MID SUSSEX DISTRICT COUNCIL

DM/21/1653

BYANDA BRIGHTON ROAD HASSOCKS WEST SUSSEX BN6 9LX DEMOLITION OF BYANDA (A SINGLE RESIDENTIAL PROPERTY AND ANCILLARY BUILDINGS) AND THE ERECTION OF A 60 BEDROOM RESIDENTIAL CARE FACILITY, WITH ASSOCIATED ACCESS, GROUND WORKS, CAR PARKING, SERVICING, PRIVATE AMENITY SPACE, LANDSCAPING, CONSTRUCTION OF SUBSTATION UNIT AND BOUNDARY TREATMENT. (AMENDED PLANS SUBMITTED INCLUDING

REDUCTION IN BEDROOMS FROM 66 TO 60 AND CHANGES TO DESIGN, RECEIVED 23/06/2022). FRONTIER ESTATES (HASS) LTD

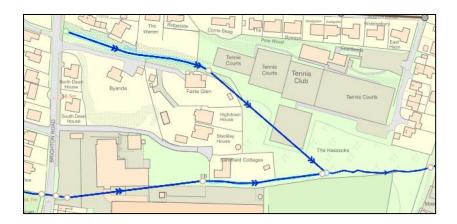
The FRA states that the area of surface water flood risk impacted by the proposed development is associated with a topographically low spot and shall be managed as part of the surface water drainage system.

The surface water flood risk on the site associated with the drain located to the north of the site is contained to the eastern edge of the site. This area is shown, in the proposed development plans, as a garden area. The FRA states that the proposed garden area shall be designed to allow flood water to continue to enter the area. Given this eastern area shall remain available to flood the development is considered to not increase flood risk to the neighbouring property due to blocking an existing floodplain.

The Flood Risk and Drainage Team consider flood risk to have been appropriately considered as part of this application. Whilst we acknowledge flood mitigation measures are no proposed due to the secondary nature of the flood risk, we continue to advise that these measures are incorporated into the development's design.

We would also advise the applicant that no land raising should be undertaken on the northern or eastern areas of the site to ensure the existing surface water flood extents are not impacted by the development.

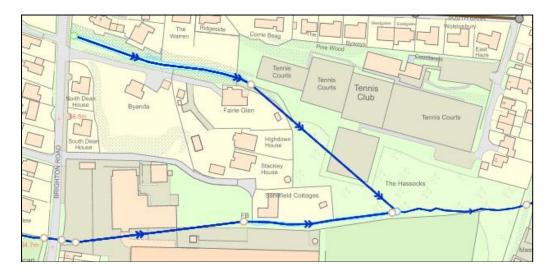
The FRA states that the area of surface water flood risk impacted by the proposed development is associated with a topographically low spot and shall be managed as part of the surface water drainage system.

The surface water flood risk on the site associated with the drain located to the north of the site is contained to the eastern edge of the site. This area is shown, in the proposed development plans, as a garden area. The FRA states that the proposed garden area shall be designed to allow flood water to continue to enter the area. Given this eastern area shall remain available to flood the development is considered to not increase flood risk to the neighbouring property due to blocking an existing floodplain.

The Flood Risk and Drainage Team consider flood risk to have been appropriately considered as part of this application. Whilst we acknowledge flood mitigation measures are no proposed due to the secondary nature of the flood risk, we continue to advise that these measures are incorporated into the development's design.

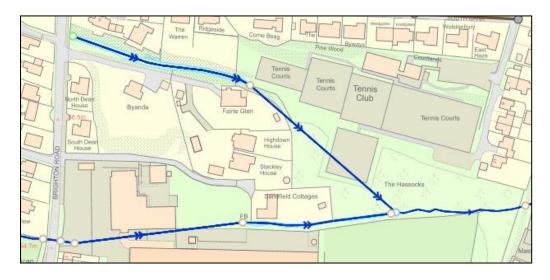
The application is supported by a Flood Risk Assessment (FRA) and Drainage Strategy report, which has been updated in July 2021 following our previous consultation responses. This report considers the historic flood event and its cause. The report concludes that further flood mitigation on the development site is not required due to the flood event being caused by poor maintenance on third party land.

The FRA states that the area of surface water flood risk impacted by the proposed development is associated with a topographically low spot and shall be managed as part of the surface water drainage system. The area of increased flood risk to the east of the site shall be a garden area and available to flood. Given this eastern area shall remain available to flood the development is considered to not increase flood risk to the neighbouring property due to blocking a floodplain.

The Flood Risk and Drainage Team consider flood risk to have been appropriately considered as part of this application. Whilst we acknowledge flood mitigation measures are no proposed due to the secondary nature of the flood risk, we continue to advise that these measures are incorporated into the development's design.

Comments dated 16/06/2021

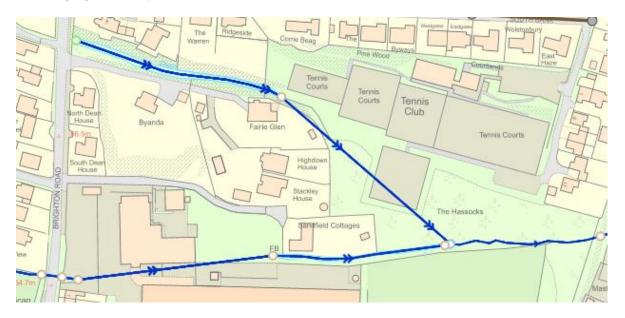
The Flood Risk and Drainage Team provided initial comments on this application on 18th May. Since this time further public comments have been provided, some of which raised concerns regarding flood risk and drainage. We have updated our response to take into consideration these comments, these additional comments have been highlighted in red text for ease of identification.

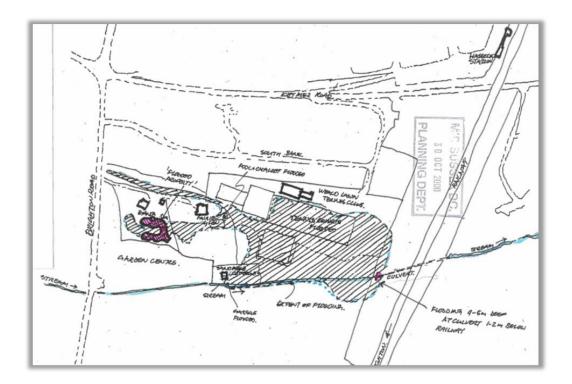
Public comment has been made that the existing system is often exceeded and flooding occurs in Faerie Glen. This would appear to be a maintenance or capacity issue within the system which should be addressed by the appropriate landowners who would have Riparian Rights and Responsibilities to this watercourse. It is the Flood Risk and Drainage Team's understanding that a poorly maintained system downstream does not prohibit a developer discharging to that system.

There are historic records of flooding occurring on this site and in this area. The Mid Sussex Strategic Flood Risk Assessment identifies a single flood event in November 2000 at Byanda. This event is classified as fluvial and resulted in internal flooding of the dwelling to a depth of 1.6m. The single recorded flood event does not mean that further flooding has not occurred on site, instead, that further flooding has just not been reported.

The source of the 2000 flooding has been identified as a blockage within the culvert beneath the railway embankment. The Flood Risk and Drainage Team consider it likely that the source of the 2000 flooding at Byanda was the Ordinary Watercourse located to the north and south. The image below provides a sketch produced by the occupier of Byanda during the 2000 flood event.
